In the Matter of the Applications of )  
 )  
AMERICAN TELEPHONE AND TELEGRAPH COMPANY )  
 )  
For Authority to Construct, Launch and )  
Operate Space Stations in the Domestic )  
Fixed-Satellite Service )  
 )

25/26/27-DSS-ML-90  
SAT-MOD-19900416-00013  
File Nos.  
6028-DSS-P/LA-87  
6029-DSS-P/LA-87  
6030-DSS-P-87

APPLICATION FOR MODIFICATION OF LICENSE

AMERICAN TELEPHONE AND TELEGRAPH COMPANY

Figure 1: TELSTAR 4 Transponder Frequency Plan

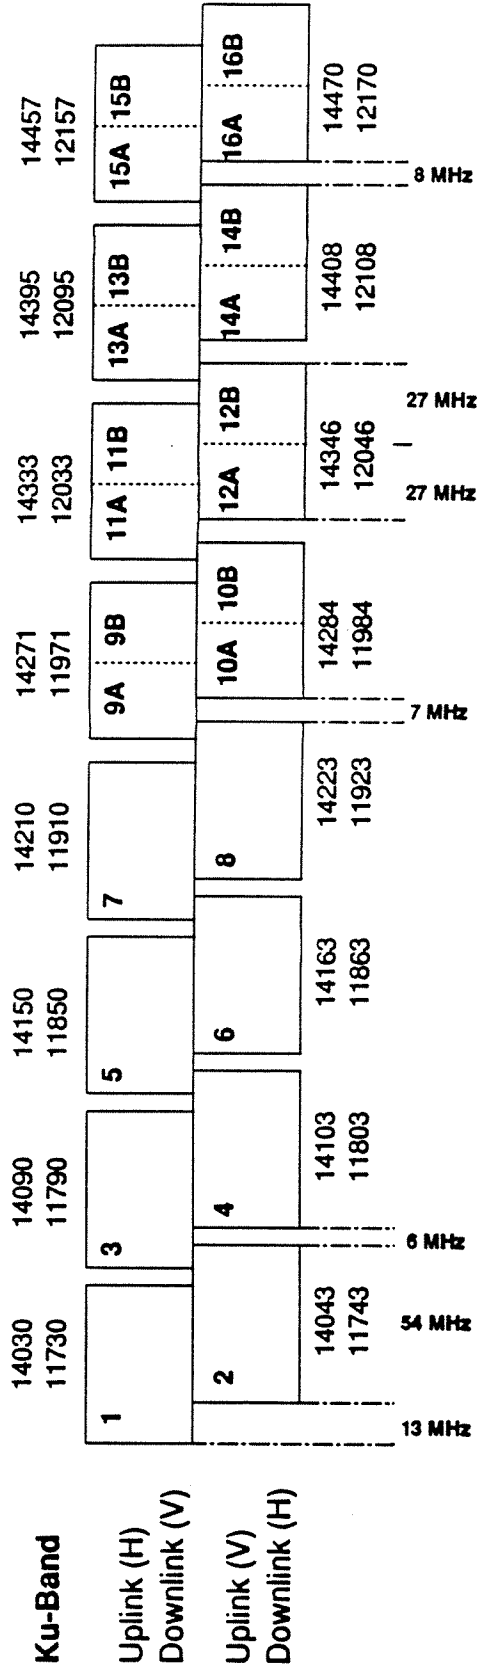
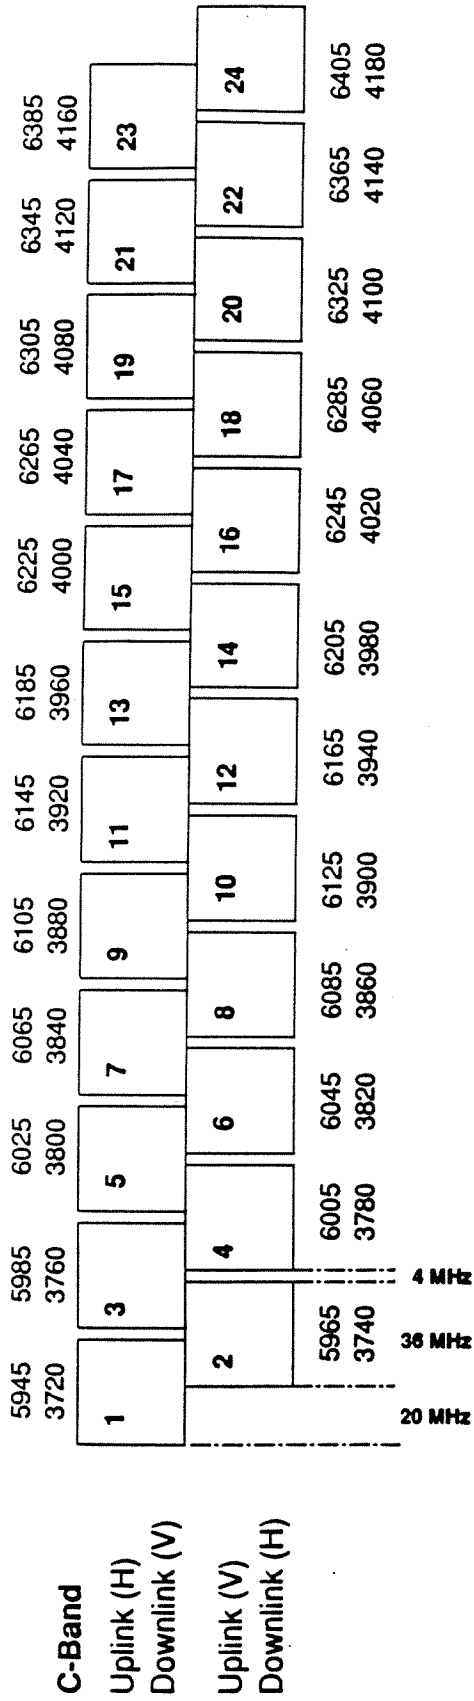
AT&T requests a change in the Ku-band frequency plan at 12/14 GHz to include sixteen transponders with 54 MHz bandwidth channels, in lieu of the previous plan which included eight 54 MHz transponders and twelve 36 MHz transponders. The new plan will have the 54 MHz transponders in both the vertical and horizontal antenna polarizations.\*

\* A frequency plan is attached as Figure 1 hereto.

Ku-band 54 MHz transponders in either polarization into two transponders of 27 MHz each.\* Allowing independent 27 MHz channels, rather than requiring a customer to place two carriers in a single 54 MHz channel, affords more efficient use of power resources because intermodulation does not occur.

In order to provide more guard bandwidth to allow AT&T to enhance overall filter characteristics where the dual 27 MHz transponder feature would be available, the guard bands between the upper four 54 MHz Ku-band transponders of each polarization would be set at 8 MHz. The guard bands between the lower four 54 MHz transponders of each polarization would be fixed at 6 MHz, and those between transponders 7 and 9, and between transponders 8 and 10, would be set at 7 MHz.

FIGURE 2

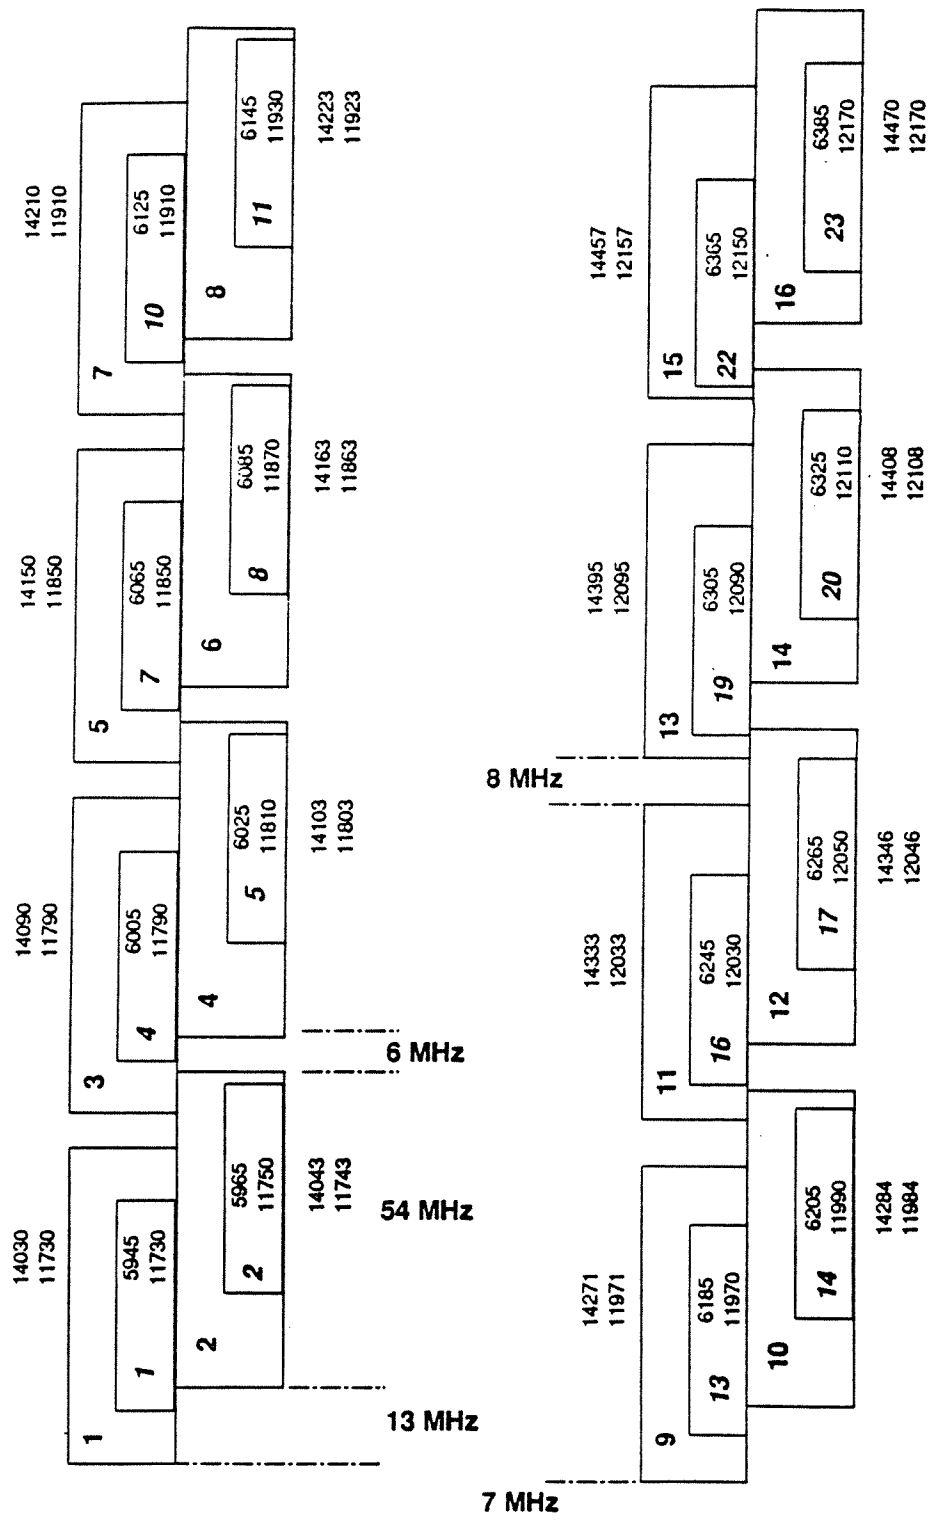
Cross-strapping capability between the Ku-band and C-band frequencies would be retained, although only 16 combinations of transponders would be cross-strapped because of the reduction in the total number of transponders in the Ku-band. Filtering and switching would be modified appropriately to permit cross-strapping between Ku-band and C-band transponders of different bandwidth.\*\*

\*\* A cross-strapping schematic is attached as Figure 2 hereto.
